Far North District Council
6 Bedggood Close, Paihia
Plan Change Three Waters Infrastructure
Peer Review

29 August 2025

6 Bedgood Close, Paihia Plan Change Three Waters Infrastructure Peer Review

Far North District Council

Figure 1.2 Austroads Guide to Traffic Management Part 6 Figure 3.25 showing warrant for CHR at approximately 10 veh/hr

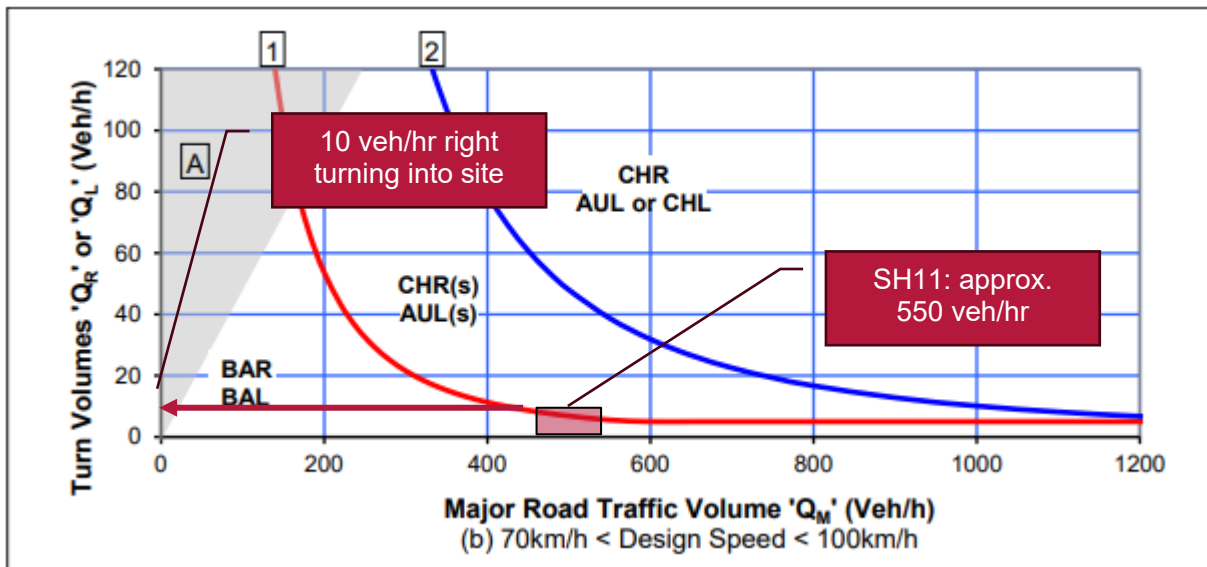
- Based on Austroads Guide to Traffic Management Part 6, a Channelised Right Turn (CHR) treatment may be required. With an estimated 550 veh/hr on SH11, a CHR would be required if the number of right turning into the site access exceeds approximately 10 veh/hr, as shown below Figure 1.2.
